IN THE MATTER OF THE APPEAL OF
BUILDING PERMIT NUMBER B425220

BZA CASE NUMBER 16604

MEMORANDUM IN SUPPORT OF APPEAL OF PERMIT B425220

EXPERT REPORT OF J. KIRK WHITE

Architectural Plans A-1 and S-1

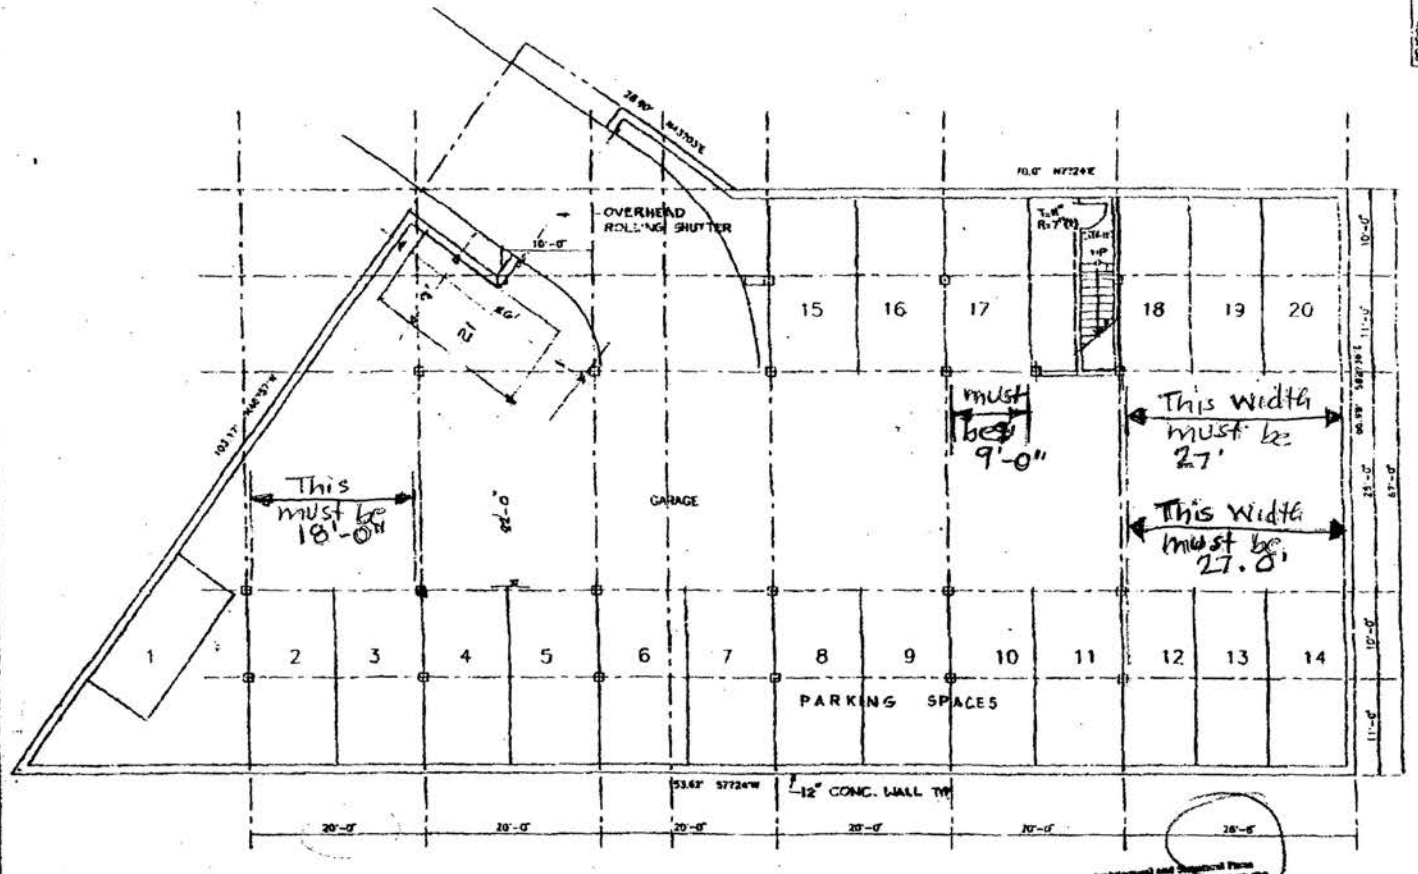
[4] Permit B425220 also violates the parking requirements of the Zoning Regulations. Six of the underground parking spaces do not meet the minimum zoning requirements of 11 DCMR Section 2115.1 which requires a minimum of 9 feet in width exclusive of columns. Spaces numbered 12, 13 & 14 and 18, 19 and 20 are not the required combined width of 27 feet. See proposed temple off-street parking level plan , Exhibit 3.
